**June 6, 2013  
Nebraska Association of County Officials – Addition and Remodel  
Lincoln, Nebraska**

-----  
**ADDENDUM #2**

A. KEY NOTES

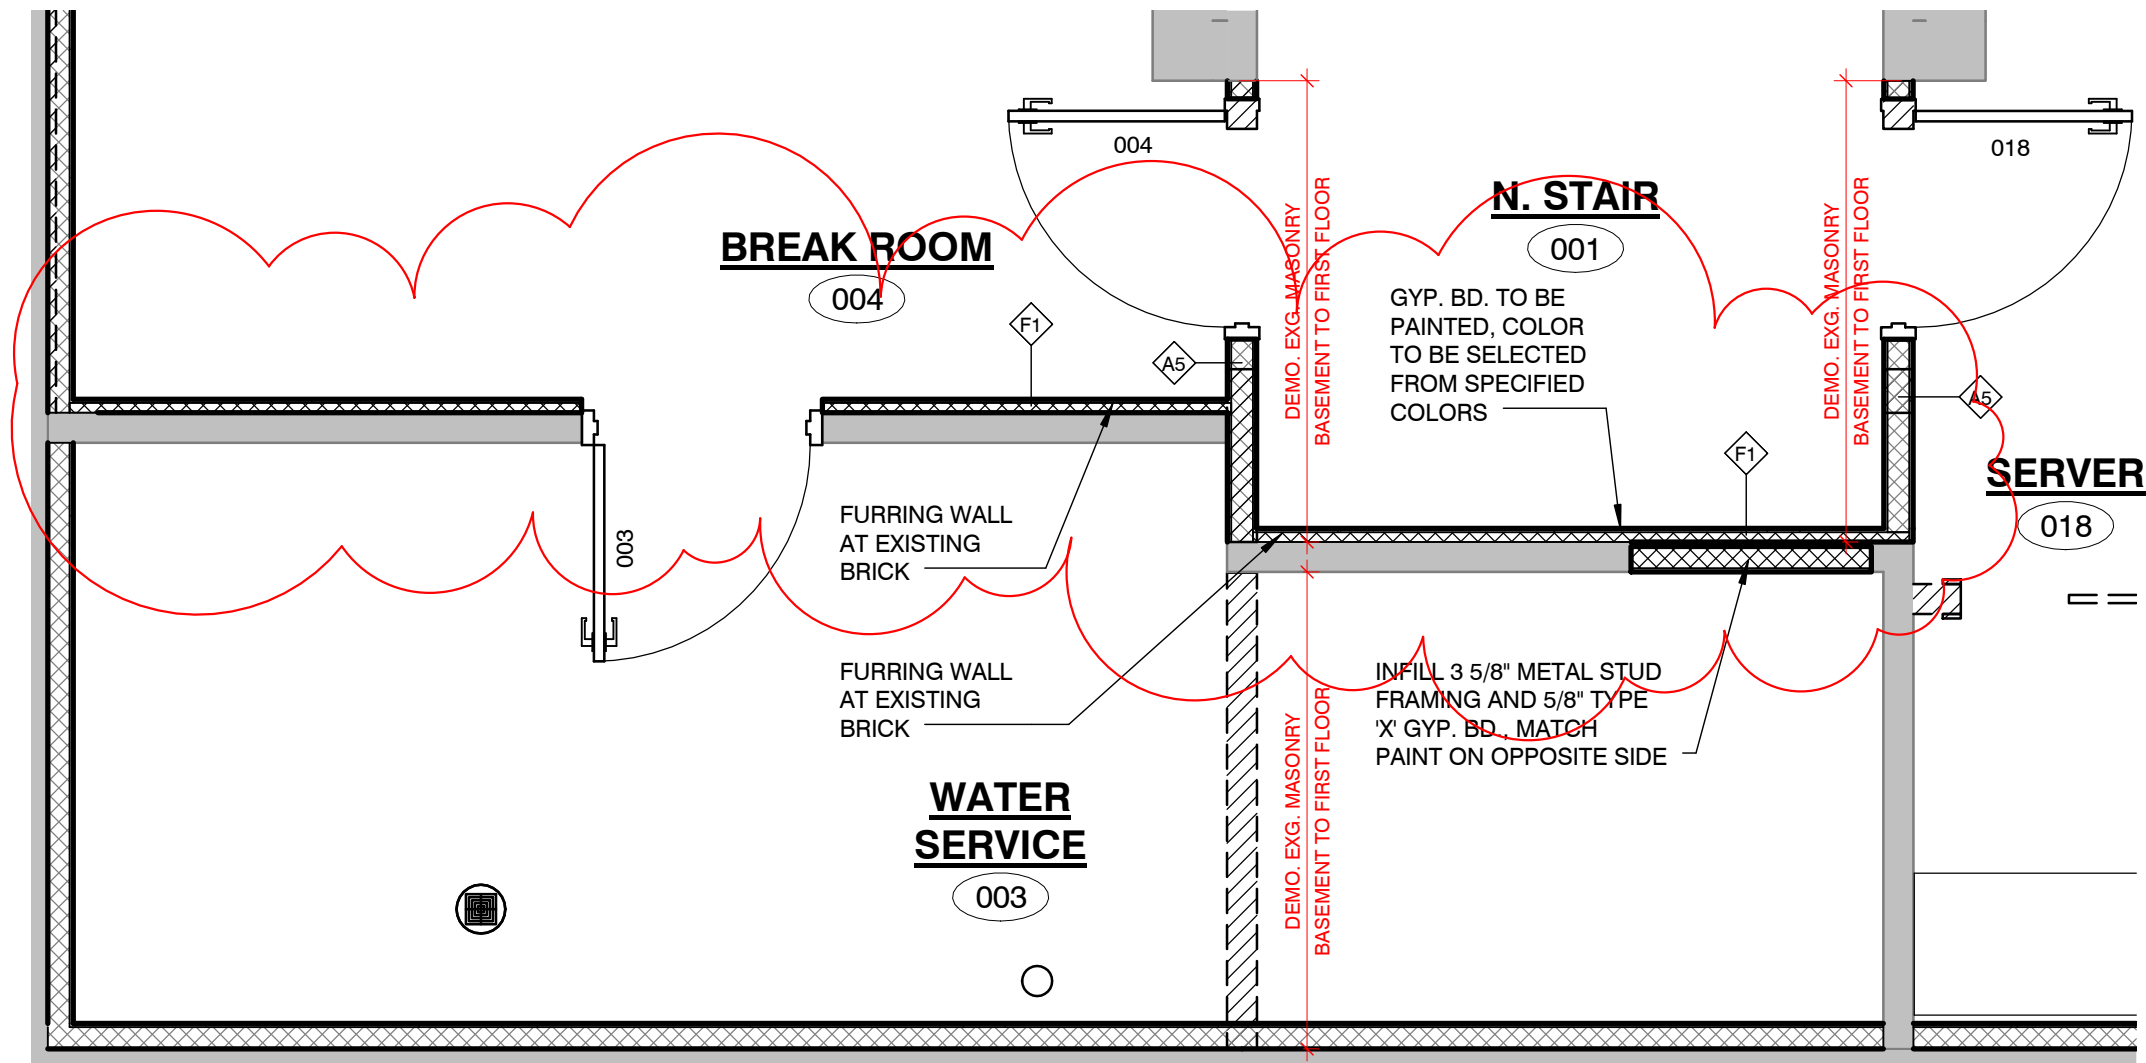
1. Key Note #4 – Delete Key Note #4 from Addendum #1 Sheet E2.0 Number 3 of 3, and replace with the following “4. ELECTRICAL CONTRACTOR SHALL COORDINATE WITH TIME WARNER TO RELOCATE OVERHEAD CABLE TO SW CORNER OF HOUSE AND RECONNECT. THE CONTRACTOR SHALL INCLUDE ALL COSTS FROM TIME WARNER FOR THIS WORK.”

**1 ADD 2 - BASEMENT**

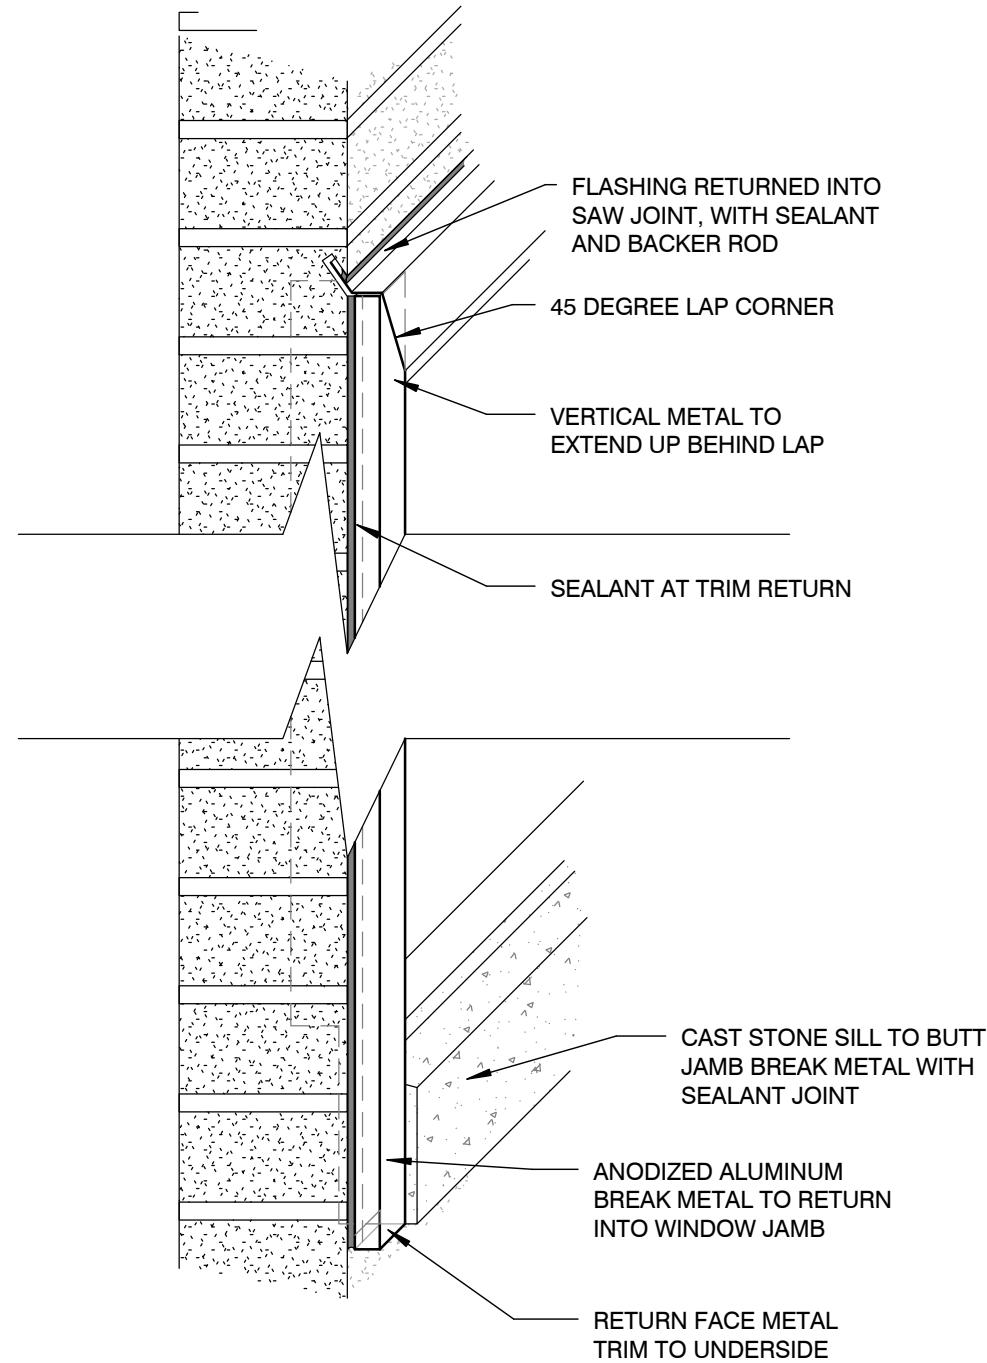
- A. 1 – DEMO – BASEMENT Add general note to plan “SEE AD2.1\1 FOR REVISED DEMO AT NORTH STAIR LANDING”

- A. 3 PLAN - BASEMENT  
1. Add General – Add the following note “SEE AD2.1\1 FOR REVISION OF NORTH WALL IN ROOM 004(BREAK ROOM), AND NORTH, EAST AND WEST WALLS IN ROOM 001(N. STAIR),”

**2 DETAIL - PUNCHED WINDOW JOINT**

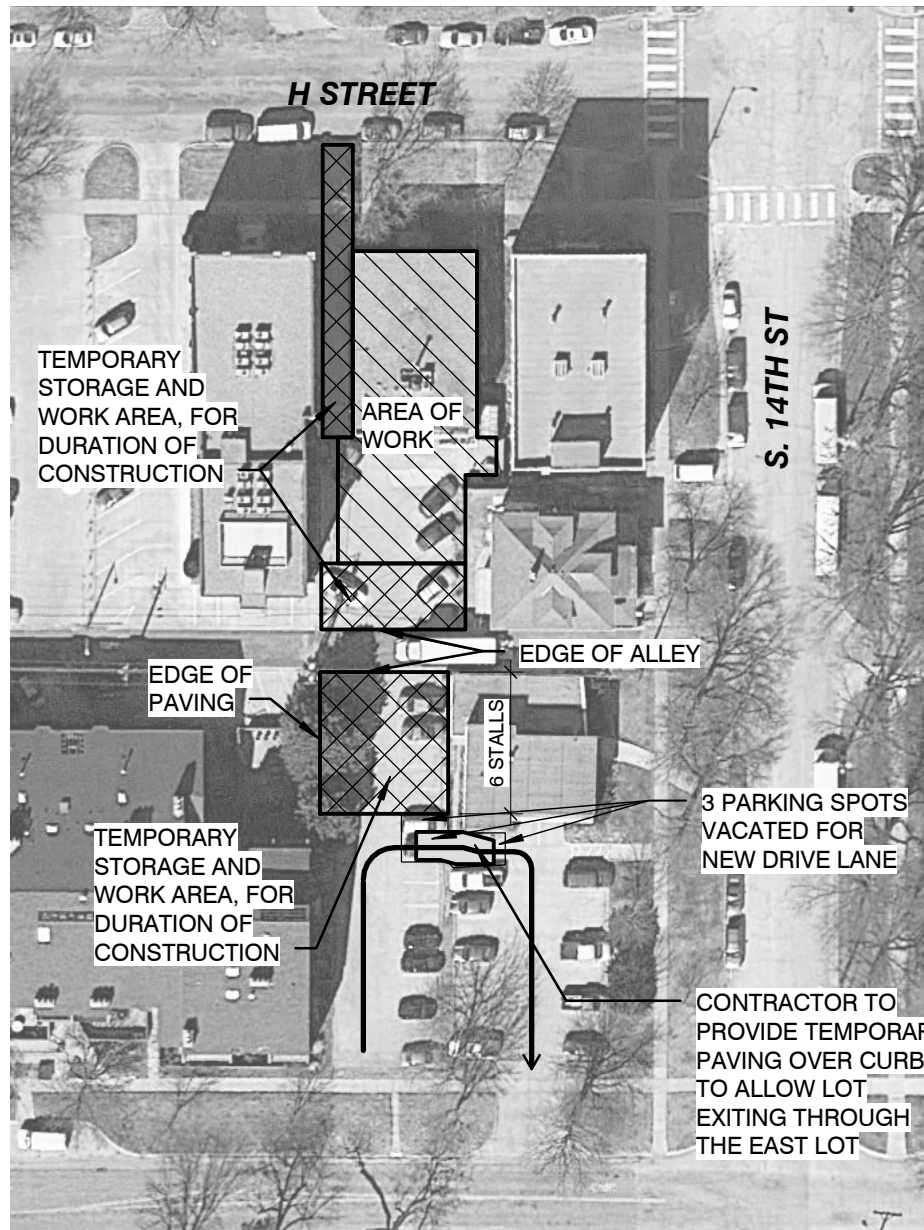
- A. 3 ALUMINUM FRAME TYPES  
1. Add note – Add the following note “SEE AD2.2\2 FOR FLASHING DETAIL AT THE HEAD AND JAMB OF THE PUNCHED WINDOW OPENINGS”

Revised Schedules

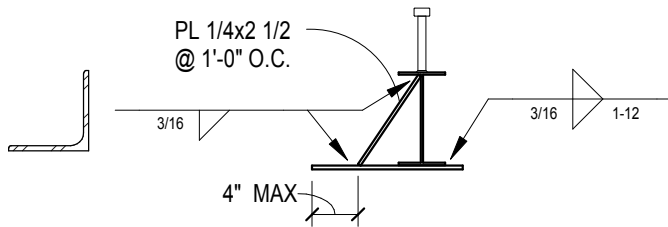
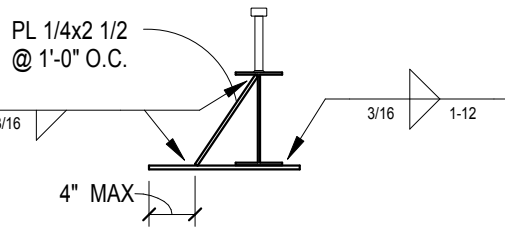
- A. LINTEL SCHEDULE  
1. See attached sheet AD #2 for Revised Lintel Schedule and Types

LINTEL SCHEDULE				
Type Mark	Bearing	Type	Description	Remarks
L-1	-	1	8"x16" CONCRETE LINTEL w/ (2) #4's BOT	
L-2	8"	2	(2) COURSES GROUTED SOLID w/ (2) #4's BOT	
L-3	8"	3	L5x5x5/16xCONT	HOT-DIP GALVANIZE
L-4	4"	5	W8x18 w/ BOT PL5/16x0'-11"	HOT-DIP GALVANIZE
L-5	-	4	W8x18 w/ BOT PL5/16x1'-0 1/2"	HOT-DIP GALVANIZE

# PARTIAL FIRST FLOOR POWER

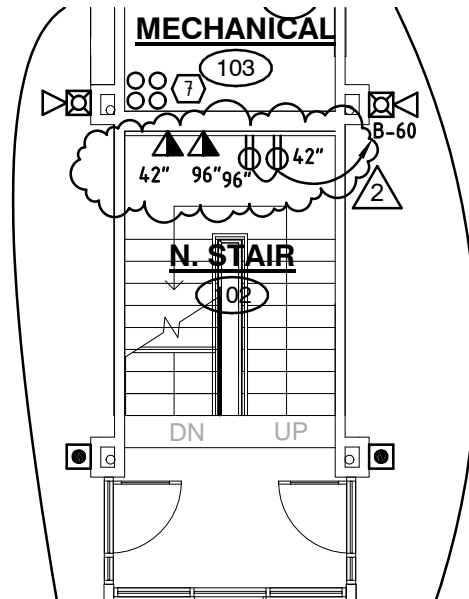
- A. Refer to Attached Sheet E2.1 (1of1) for addition of device in Stair #102.
